# TOYOTA

## SERVICE BULLETIN

REFERENCE	BODY
NUMBER	043
DATE	02-06-87
MODEL	AL3#, AE8#, AW15 SV1#, CV13, ST6# MA7#, MX73.

### COWL TOP VENTILATOR LOUVER

Cowl top ventilator louver  
(Mesh size: 1.6x1.6mm)

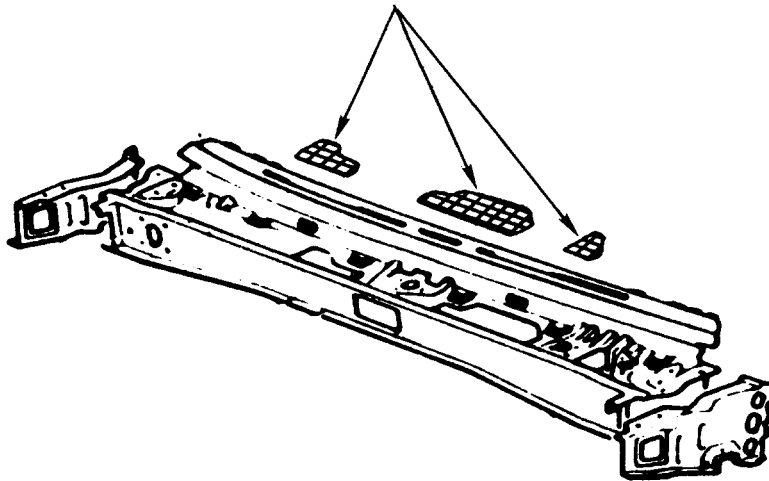
To reduce snow entry into the ventilation system of the vehicle, wire mesh type cowl top ventilator louvers have been adopted for cold specification models.
